工程指示 / 要求簡箋(E.I.)

工程指示編號：EI / 0233 / 19

工程名稱：觀塘裕民坊

工程項目：Plenum Box 大圖 修改

TITLE : TOWER AIR PLUMBING BOX SCHEDULE
(PRELIMINARY FOR KITCHEN)

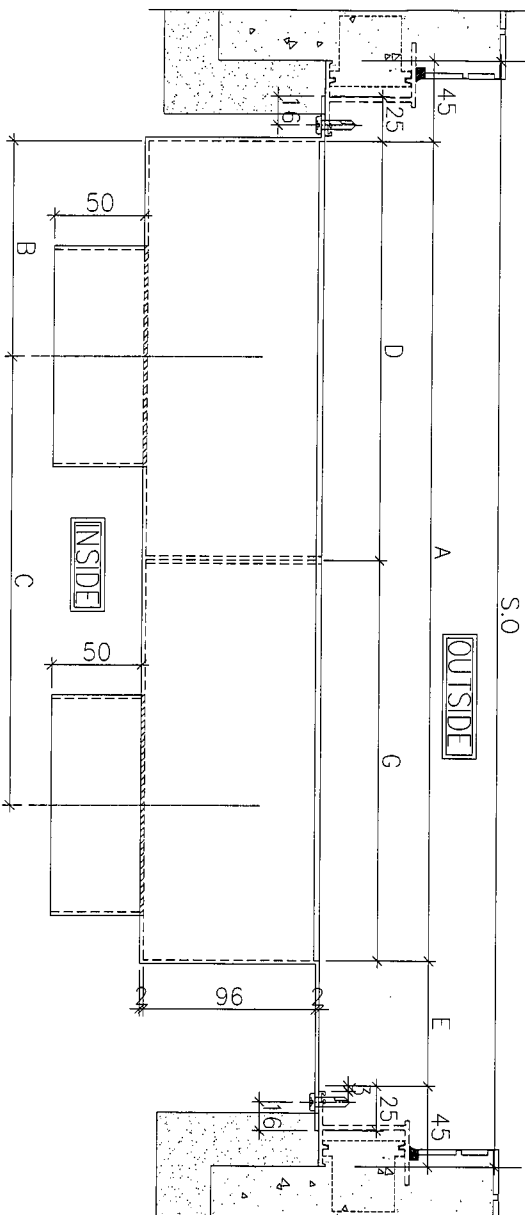
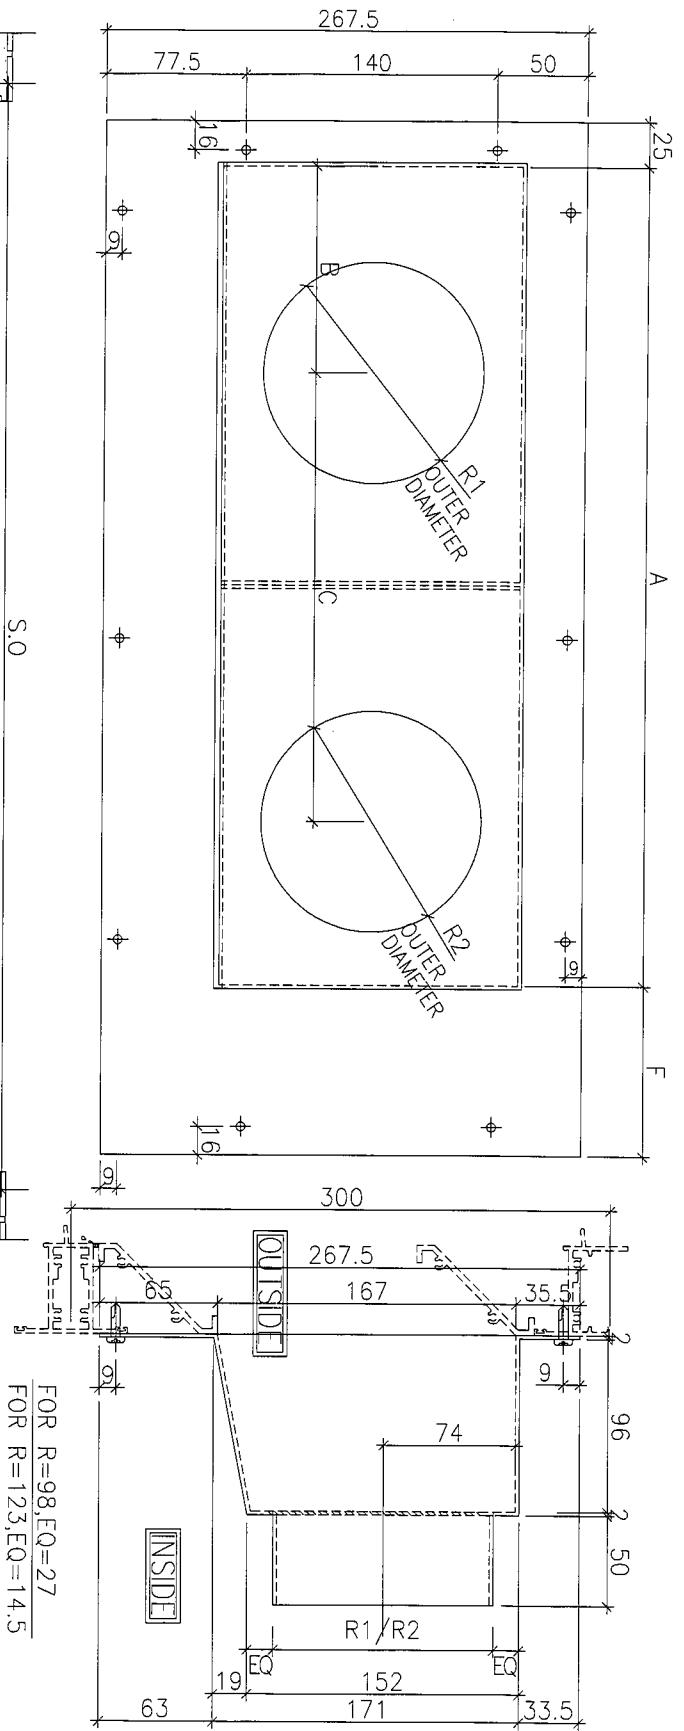
現確定圖號 PB2118 箱號 T5P/G-K 圈起的資料(即是 F 的數值)要修改。

(F=280+25=305) 修改版存仁
